South Texas Project Electric Generating Station 4000 Avenue F – Suite A Bay City, Texas 77414

July 30, 2008
ABR-AE-08000056

South Texas Project
Units 3 and 4
Docket Nos. 52-012 and 52-013
Response to Requests for Additional Information

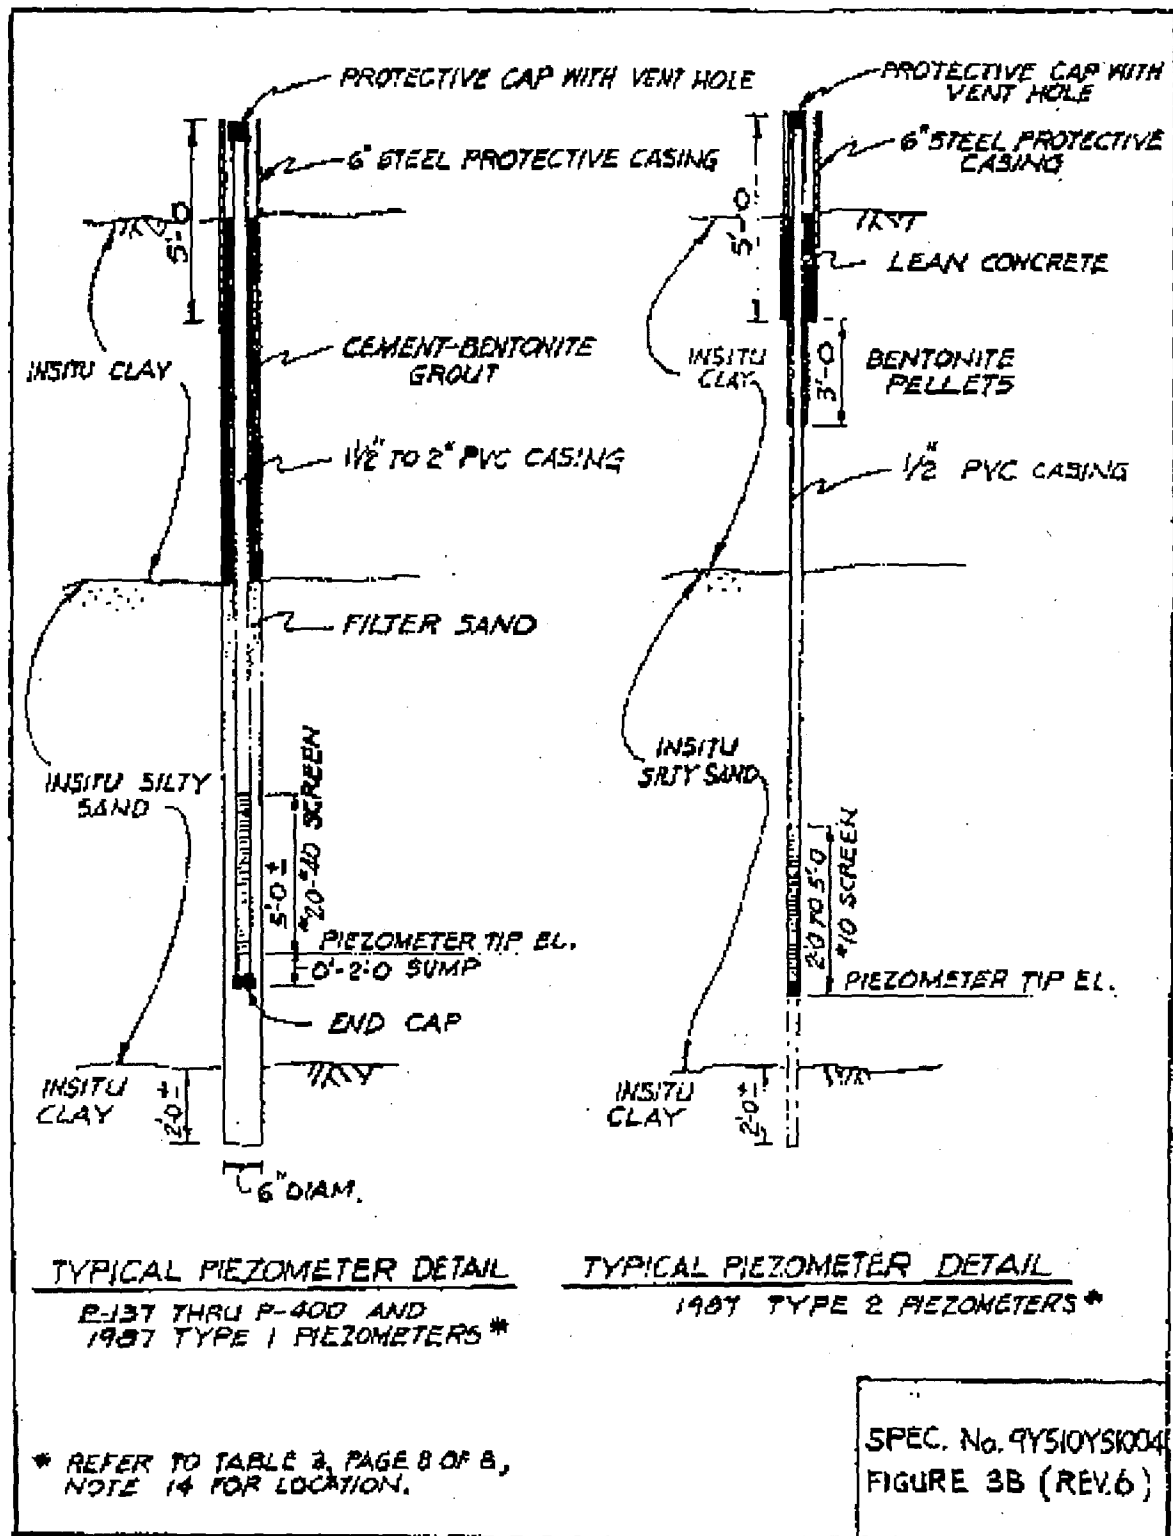
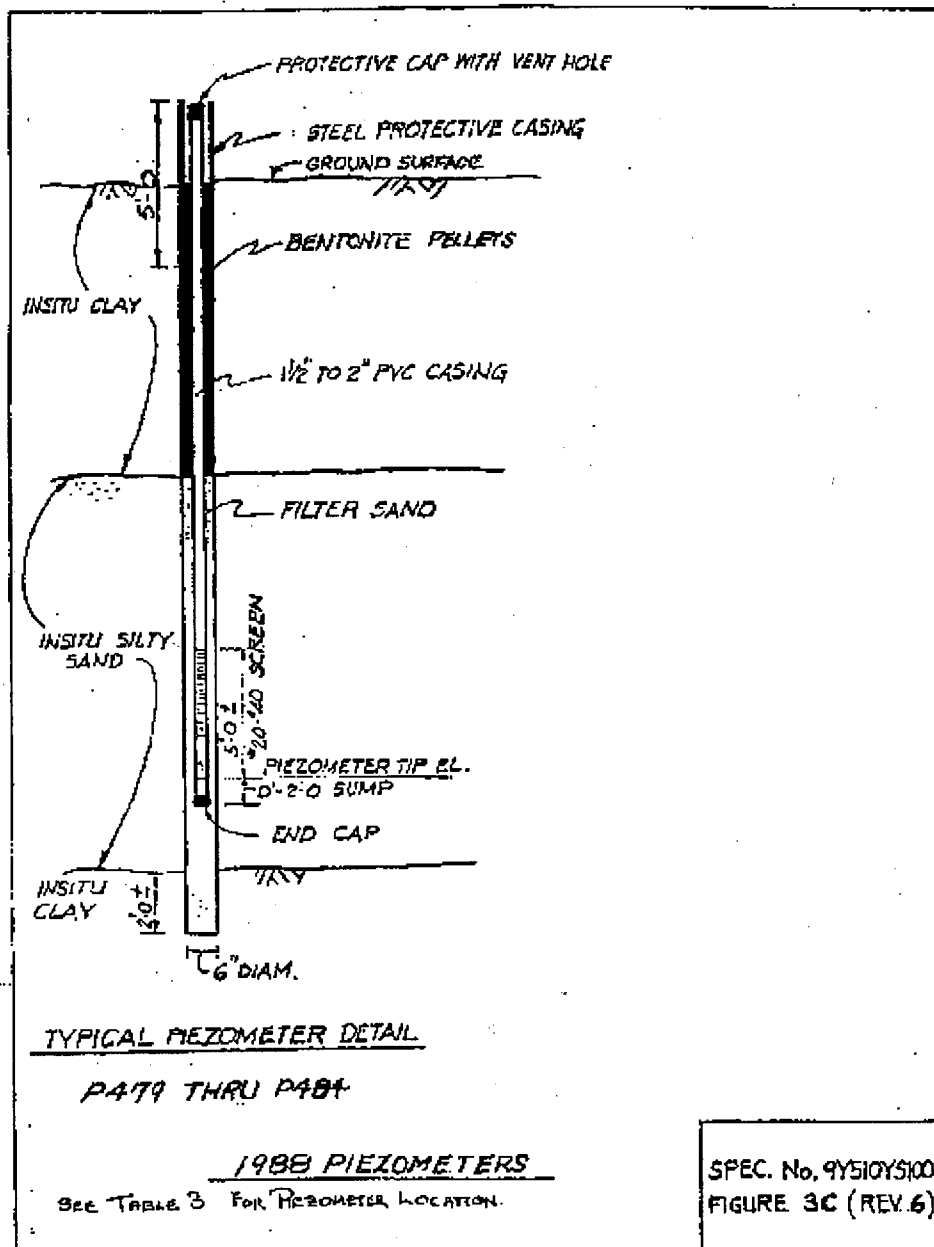
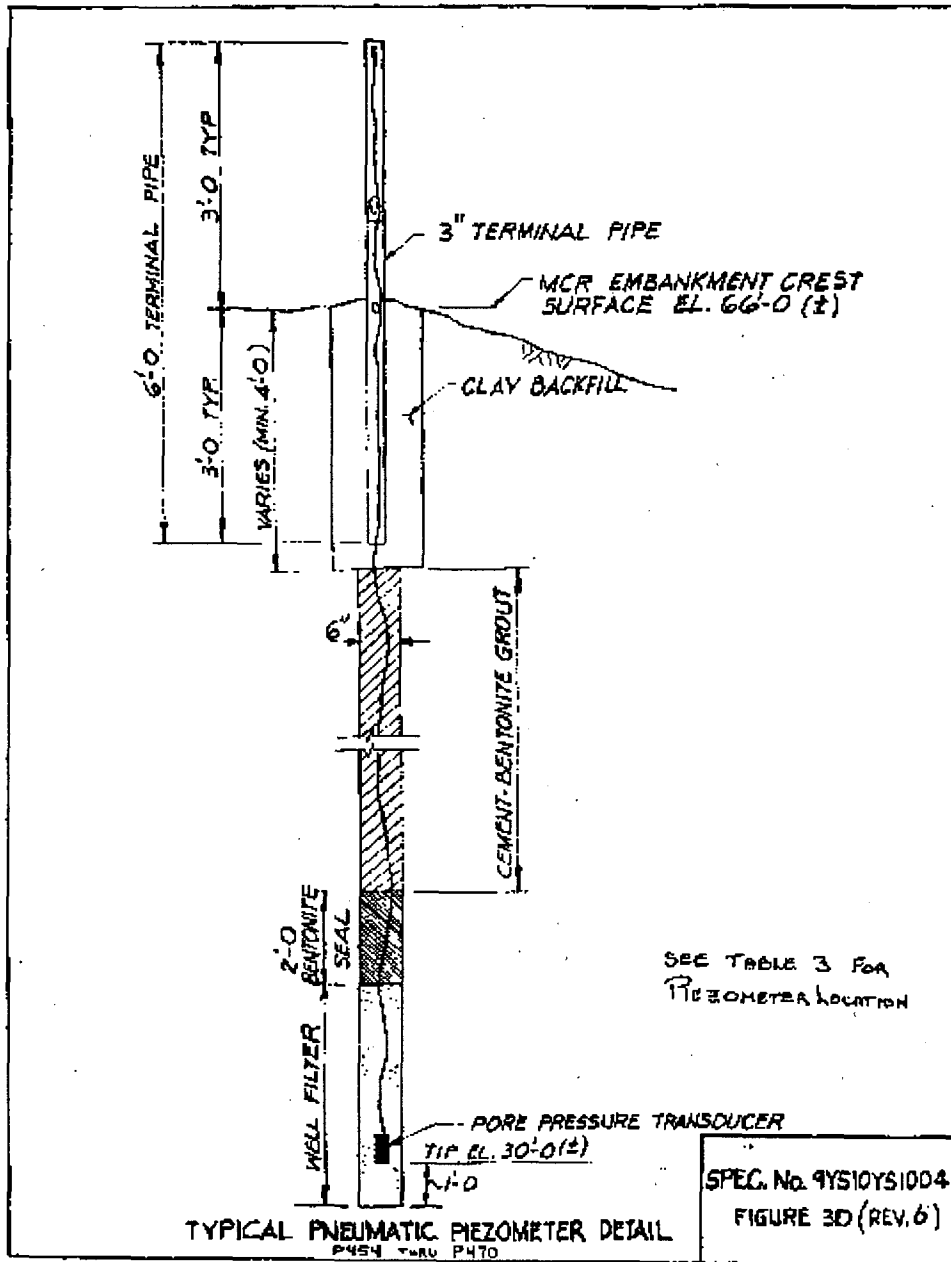
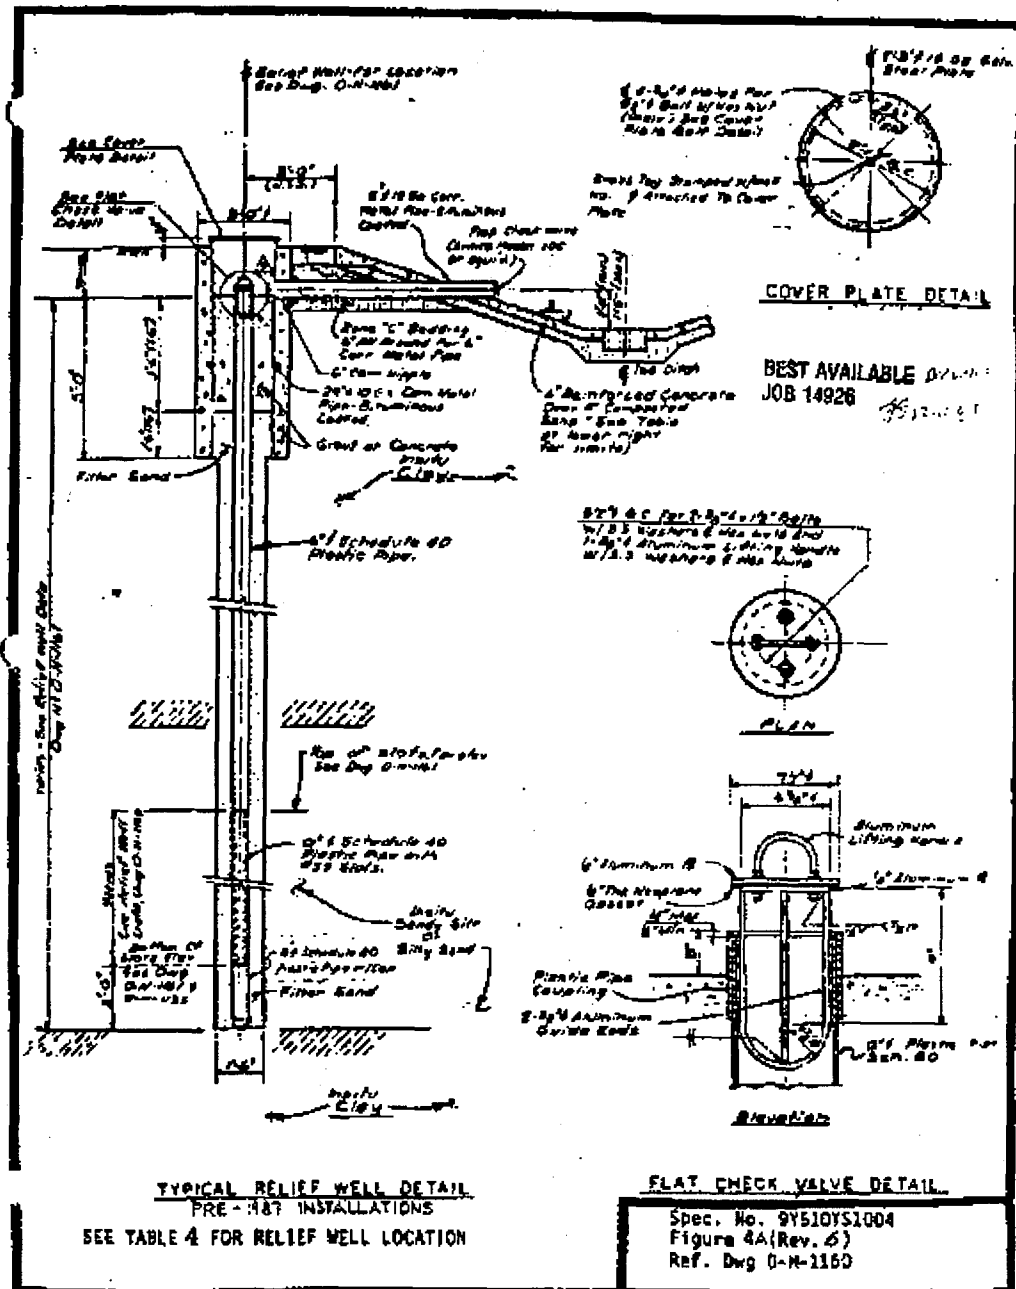
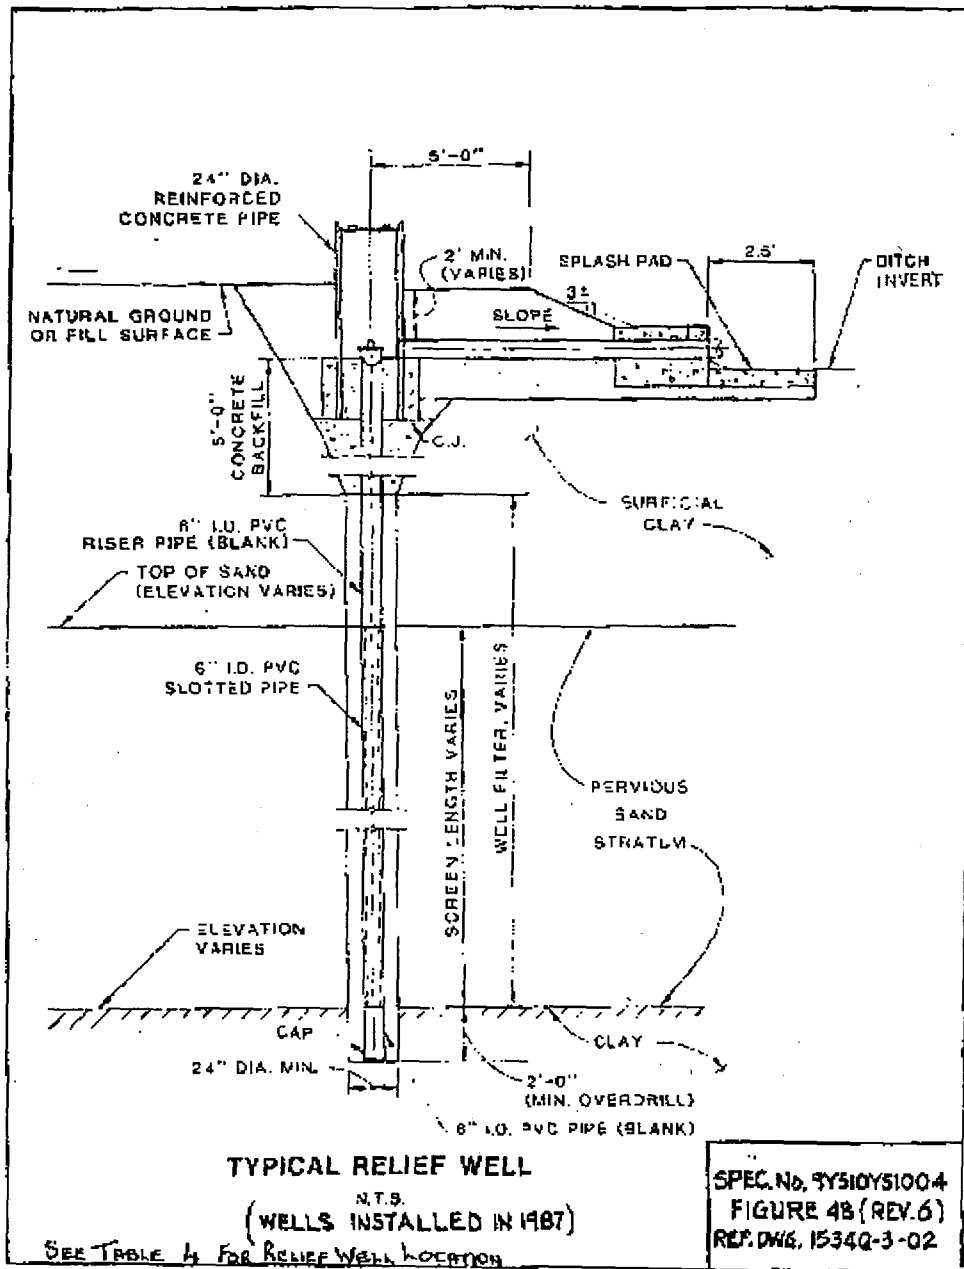
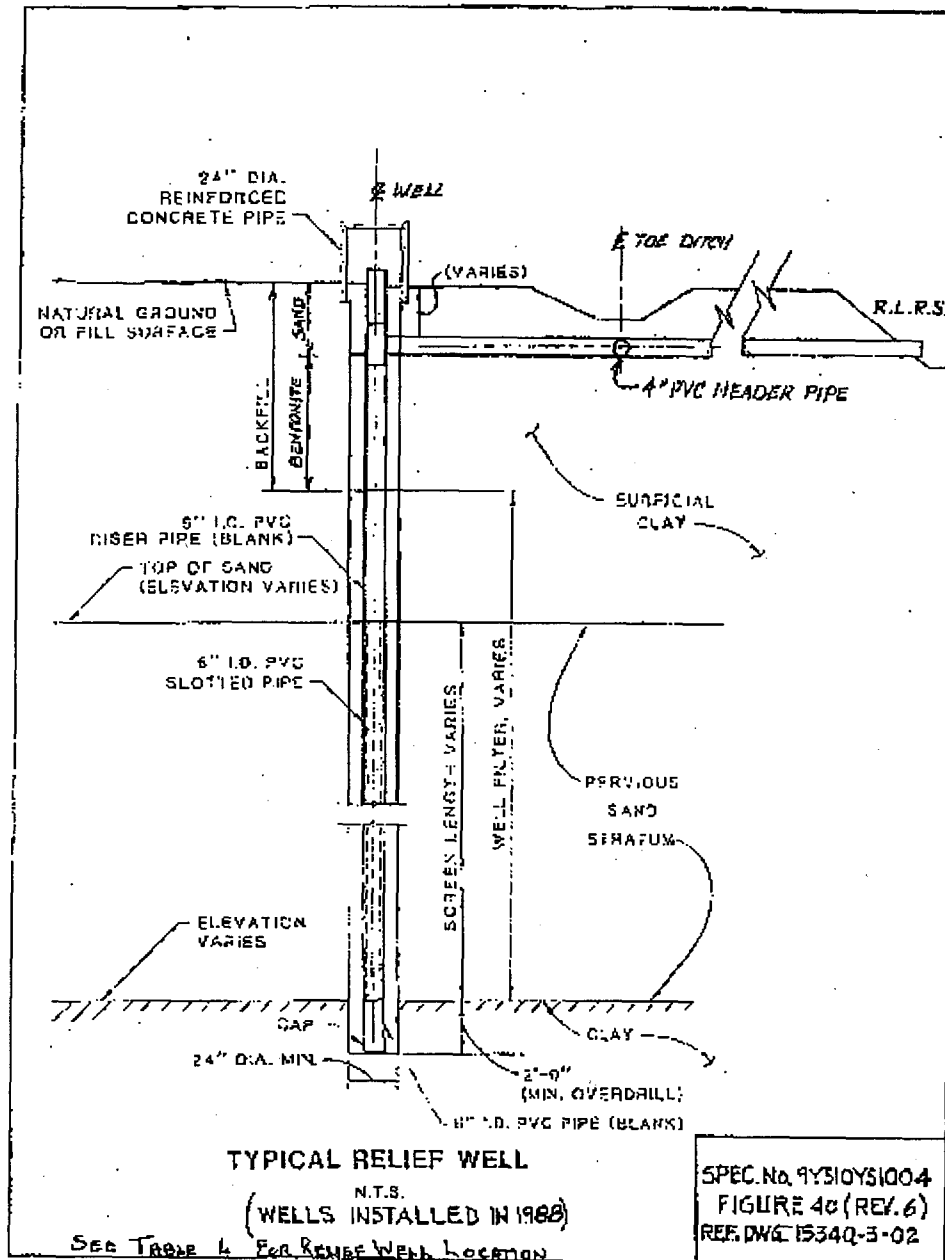
Provide construction details, purpose, and function of relief wells surrounding the MCR.

- (a) Provide construction details of the MCR relief wells, (i.e., screened interval and depth) and describe the purpose of the relief wells. If the MCR relief wells are designed and function to maintain the structural integrity of the dike surrounding the MCR, then state that purpose and describe briefly how it is achieved. If the MCR relief wells are designed to isolate the MCR hydraulically from the Upper Shallow Aquifer, then state that purpose and describe briefly how it is achieved.

Examples of MCR relief well construction details are provided in the attached drawings from the STP Units 1 & 2 UFSAR (Figures 35, 3C, 3D, 4A, 4B, and 4C). The relief wells are a passive system designed to reduce the exit gradient of seepage from the MCR that could result in heave or boiling of the top stratum.

The following revisions to ER Subsection 2.3.1.2.3.3, third paragraph, are suggested to clarify the role of the MCR relief wells. Inserted information is summarized from the STP Units 1 & 2 UFSAR:

Figure 5.3-1 Summer Salt Deposition

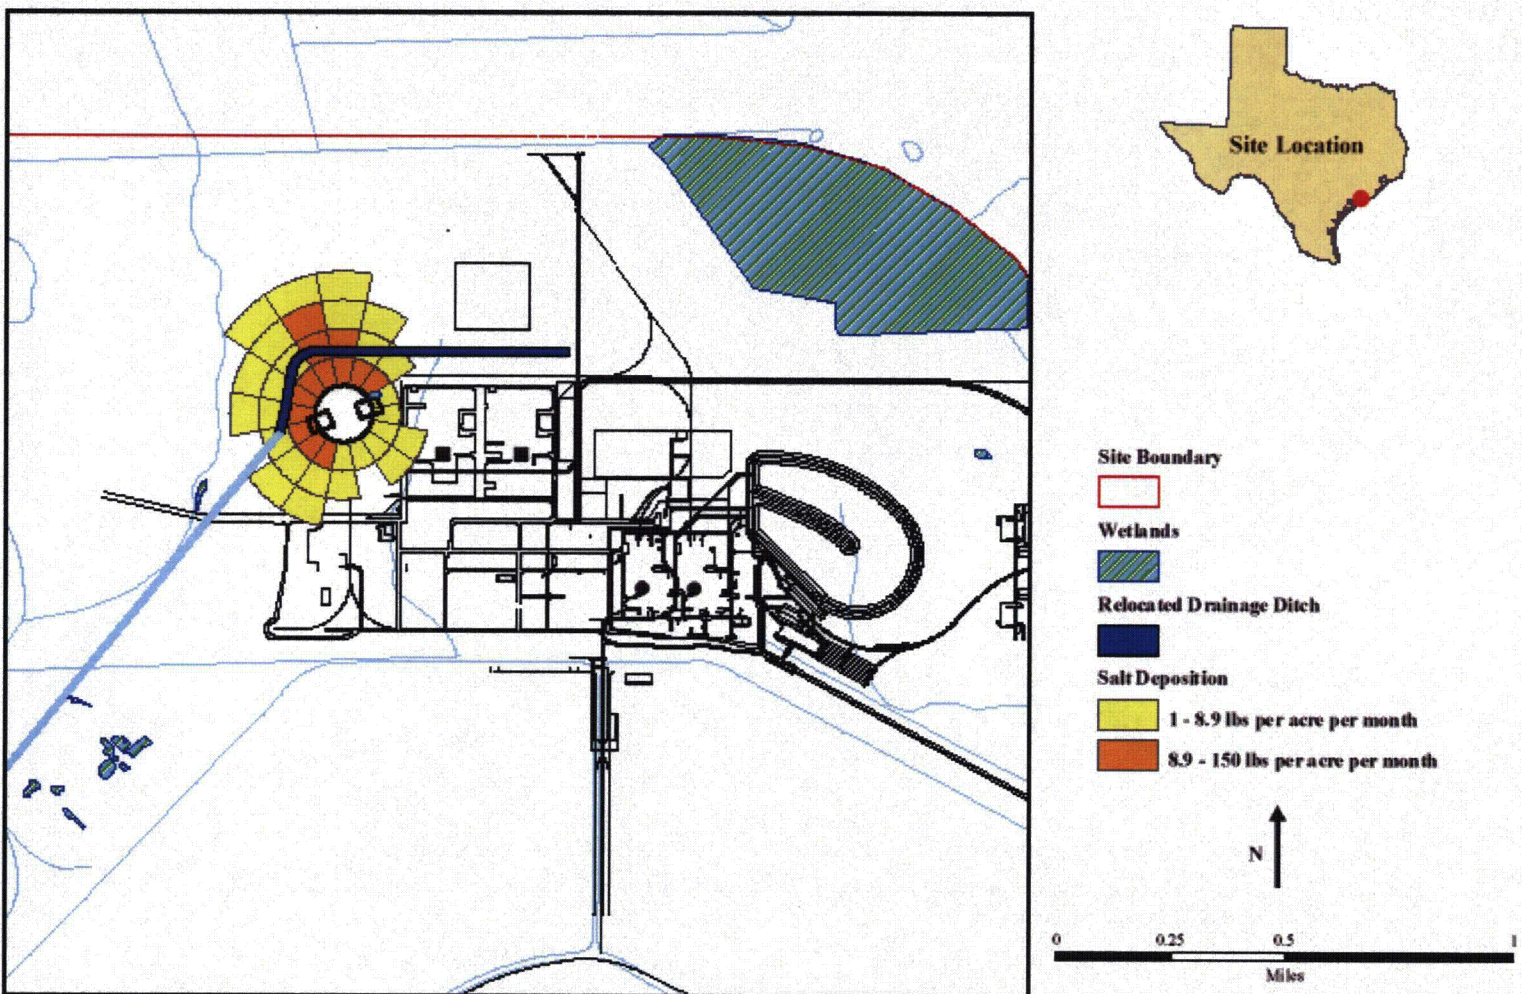
Provide graphics that illustrate the salt deposition isopleths overlaid on existing habitat maps and wetland maps.

The extent and distribution of salt drift and deposition have been modeled and described verbally in the ER. Provide graphics that illustrate the salt deposition isopleths overlaid on existing habitat maps and wetland maps.

The attached figure shows the salt deposition isopleths overlaid on the habitat and wetlands maps.

The results shown on the attached new Figure 5.3-1 are based on SACTI predictions using the site layout as provided in Revision 1 of the COLA ER. This site layout is being revised to reflect a change in the design and location of the Ultimate Heat Sink. When this design change is complete, the SACTI model will be re-run to ascertain any changes to salt deposition predictions and the changes will be reflected in a subsequent revision of the COLA ER. The attached new Figure 5.3-1 is presented to demonstrate how the figure would have been revised had there not been a design change.

Figure 5.3-1 in the ER will be replaced with the attached new Figure 5.3-1.

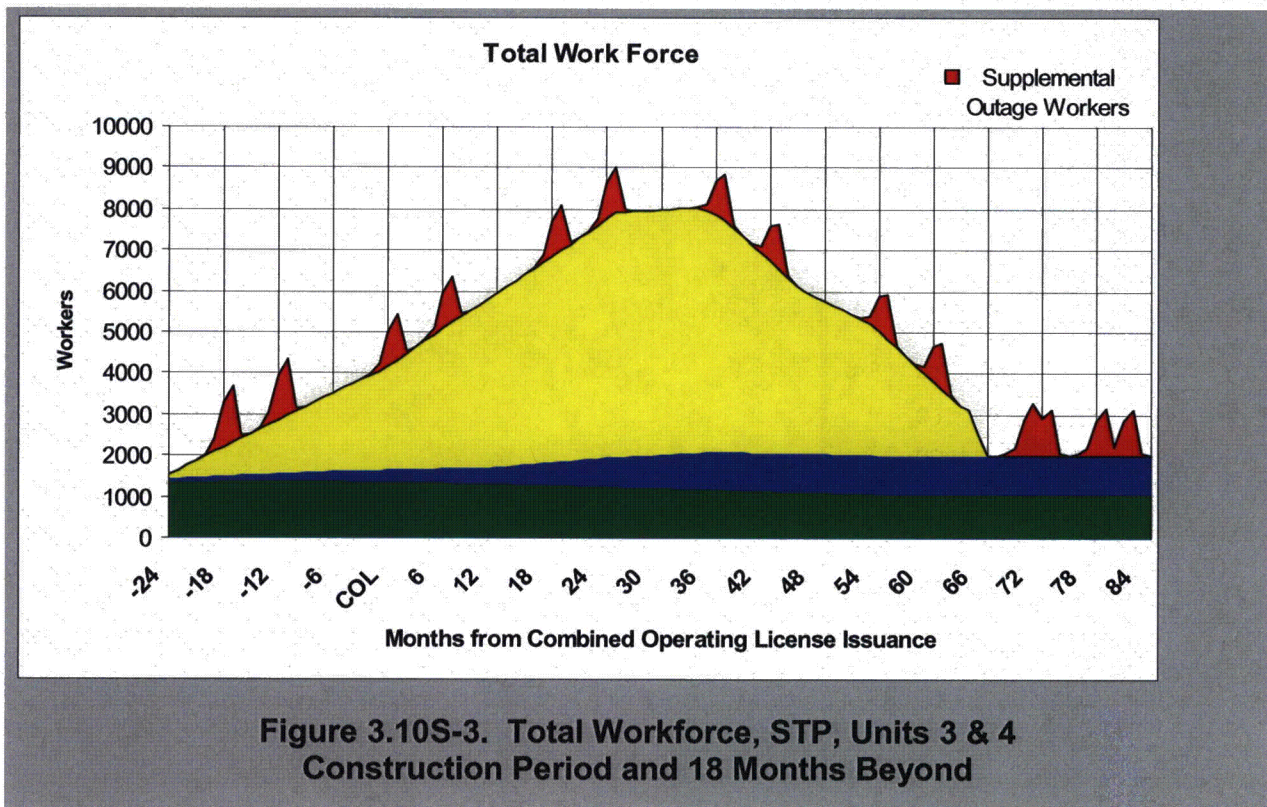
Add a month by month table of projected “workers on site”.

Add a month by month table of projected “workers on site,” to include existing operating workforce, outage workers, construction workforce for units 3 and 4, operating workforce for units 3 and 4 in Section 3–10S. The table should include an operating period with Units 1, 2, 3 and 4 all operational, with and without an outage workforce.

The table shown below contains the requested information, which is also illustrated by the accompanying figure. This table and figure will be added to Section 3.10S of the ER.

Insert new Table 3.10S-3 and Figure 3.10S-3:
